Department of Planning and Zoning

TO: Development Review Board
FROM: Scott Gustin
DATE: November 5, 2014
RE: 15-0358CA; 82 University Place

Request: Demolish Angell Hall and Cook Physical Science Building, construct new STEM building with connecting bridge to Votey Hall.

LIGHTING PLAN

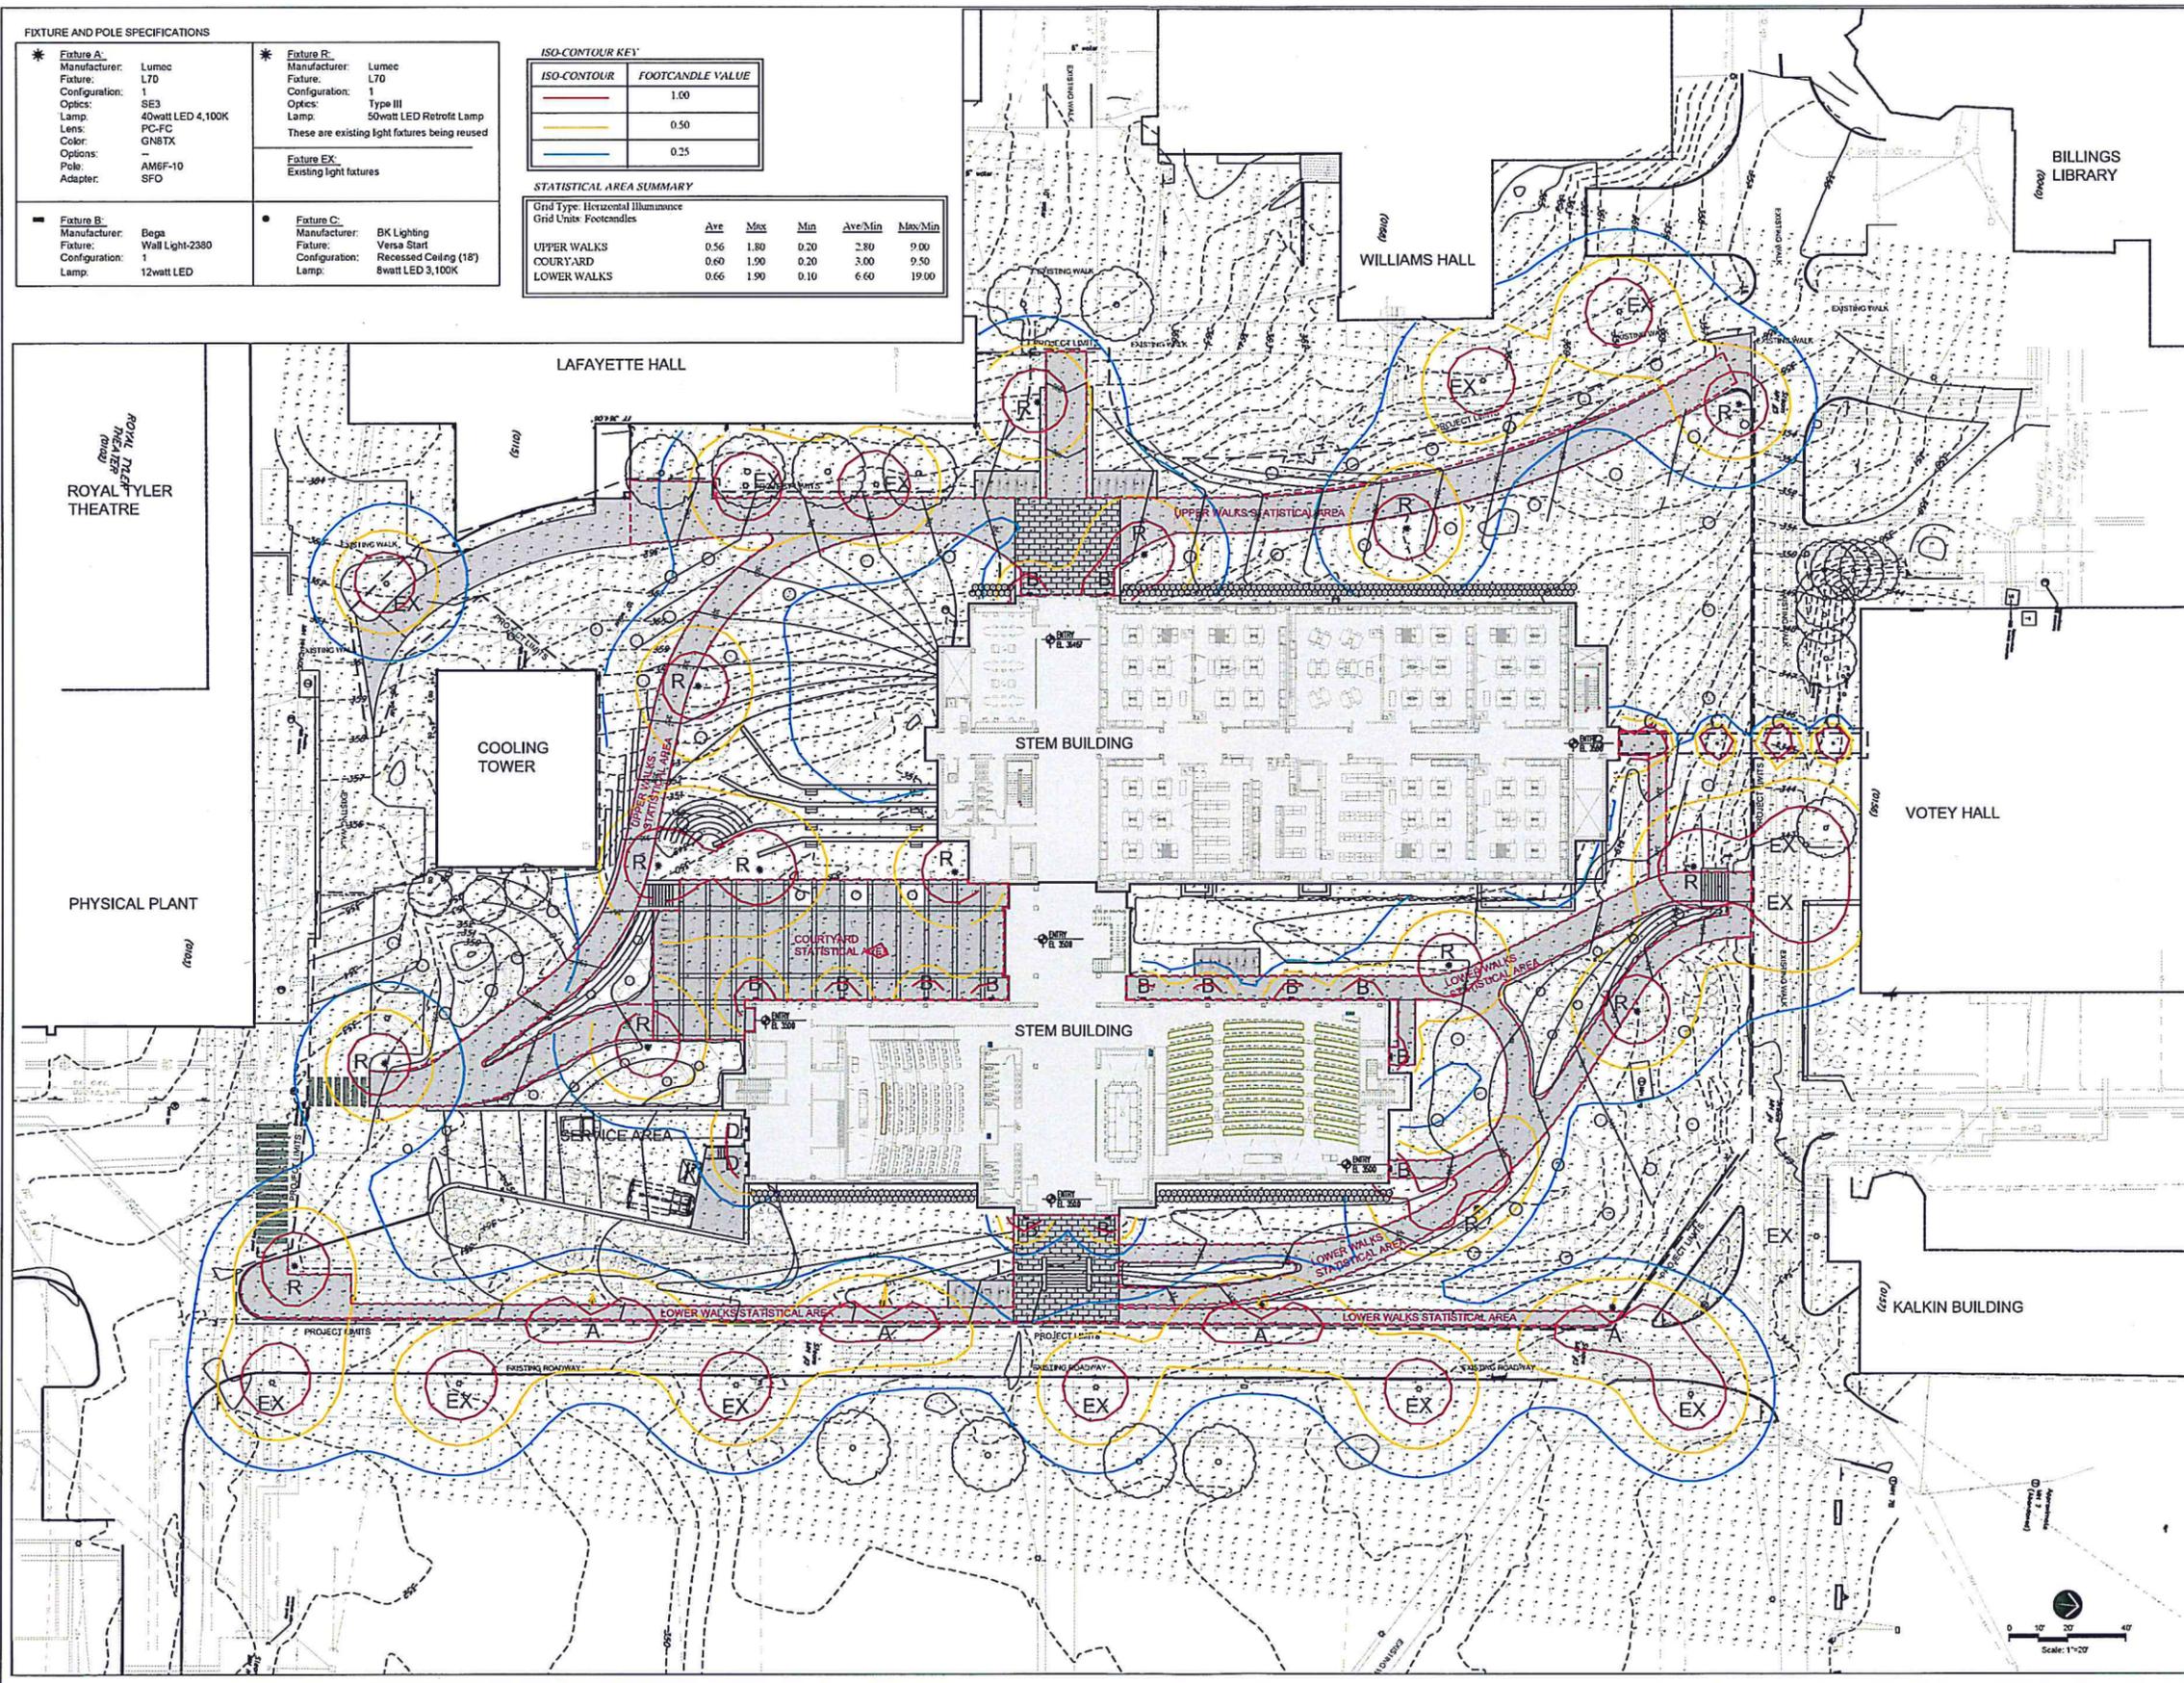
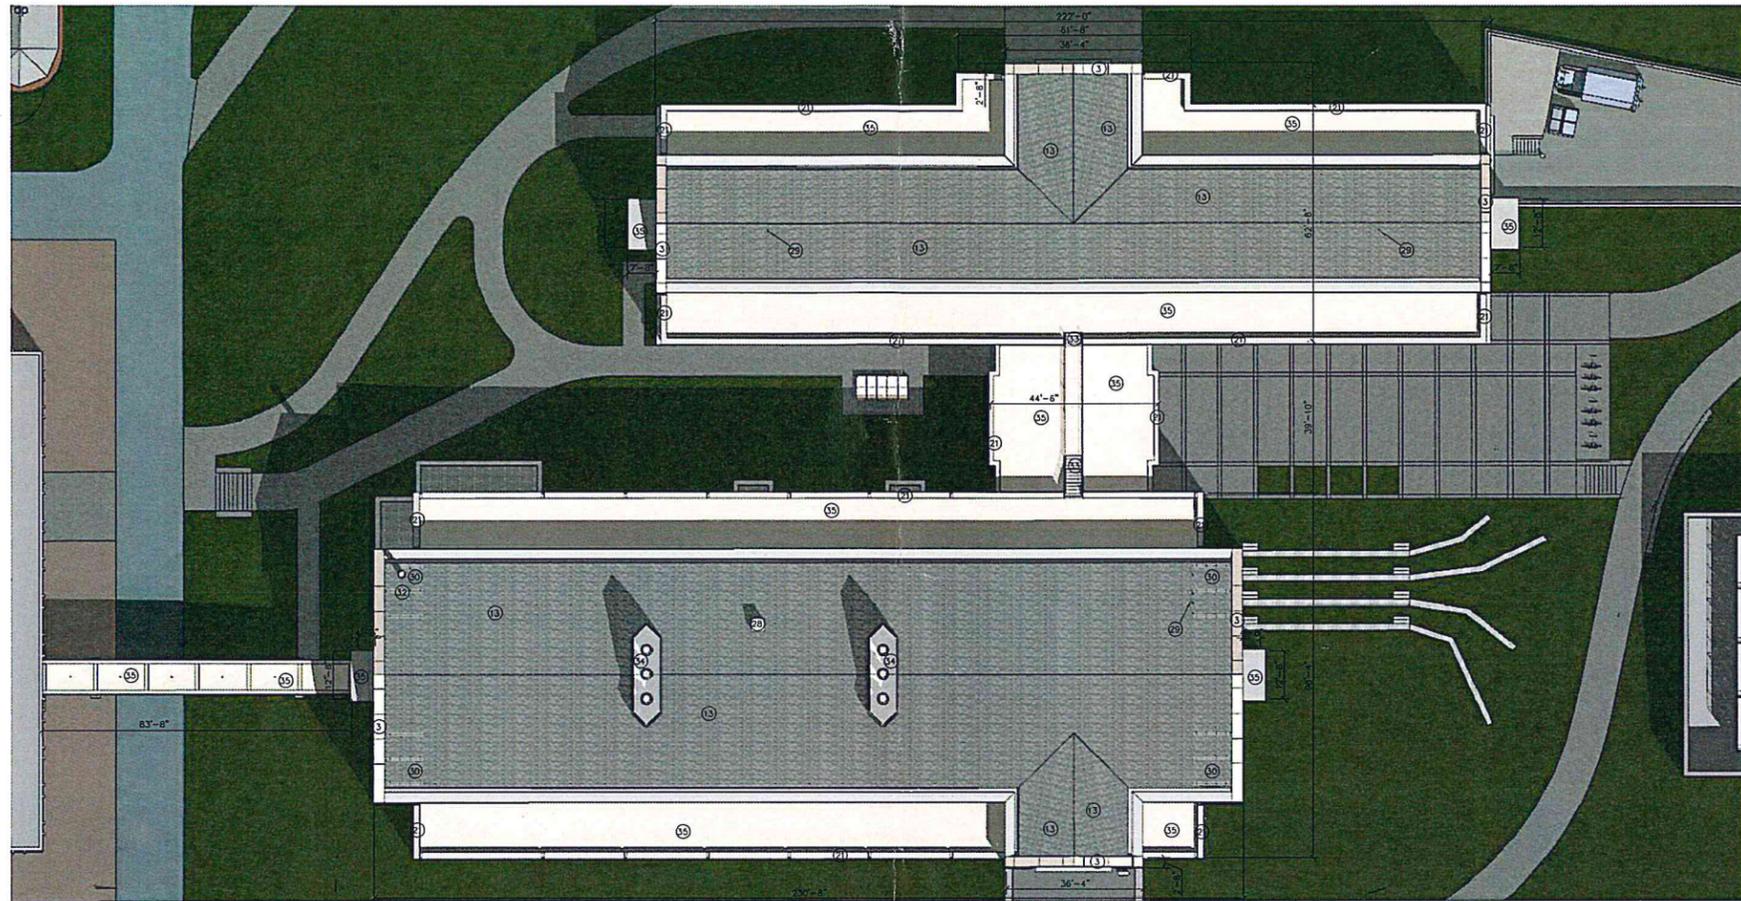
Building entries, walkways, and the plaza will be illuminated. A photometric plan has been submitted that depicts acceptable lighting levels throughout. Acceptable LED lighting fixture types are proposed. **(Affirmative finding)**
